### **RAI 4.6.3-1**

Section 4.6.3 of the LRA states that, "In addition, the steady-state temperature without cooling water and continuous RHR flow at 380 °F results in the temperature of the surrounding concrete of approximately 210 °F." Define the steady-state temperature. Is the temperature in the hot pipe containment penetration at 380°F considered as a normal operating condition? Is the temperature in the concrete that surrounds the hot pipe penetration at approximately 210°F considered as a normal operating condition? If answers to these questions are positive, please justify your results since ACI 349 Code limitation of 200°F has been exceeded. Describe how the 210°F was obtained(e.g., measured or calculated).

### Comparison of Thickness Predictions

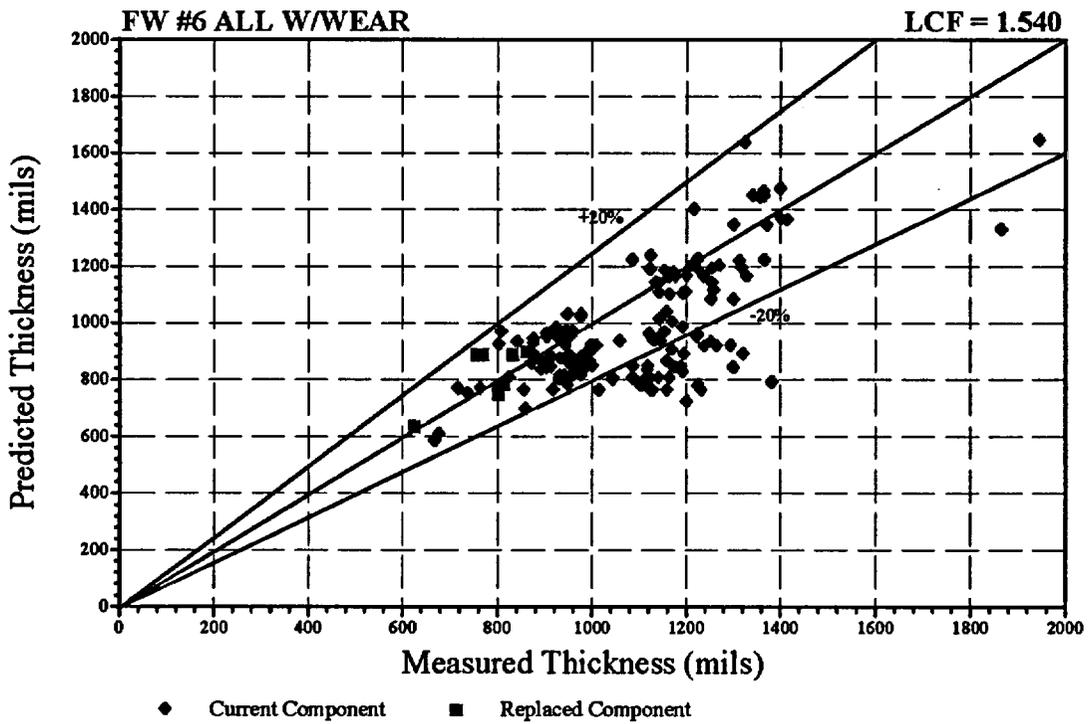
The FAC program in RNP includes prediction of the wall thinning for the components susceptible FAC. The wall thinning is predicted by the EPRI's CHECWORKS computer code. In order to allow the staff to evaluate the accuracy of these predictions, the applicant should provide a few examples of the components for which wall thinning is predicted by the code and at the same time measured by ultrasonic examination or any other measurement method employed in the RNP. This procedure will show the effectiveness of CHECWORKS in predicting the as-found condition.

Below is a chart that provides comparisons of predicted versus as-found thicknesses for RNP feedwater piping. The thickness prediction is based on initial thickness (nominal wall) minus the predicted wear over the life of the component. The predicted wear is calculated initially assuming no known wear. The wear is then adjusted based on actual measurements of many components within a line. The adjustment is a correction factor which is applied to the predicted wear in the components in the line. Normally, some components will wear less than predicted and some will wear more than predicted. The line correction factor (LCF) is derived by calculating an adjustment factor for each component, then taking the median value of these individual adjustments as the line correction factor. The actual thickness measurements vary from predictions due to variations in initial pipe wall thickness, e.g., some components are substantially thicker than nominal. The data points in the non-conservative direction are a result of higher than median wear, combined with initial thickness values close to nominal.

Also provided below are data sheets from several systems within the program scope. These data sheets contain data points (in inches) for measured thickness, predicted thickness, and minimum allowable thickness.
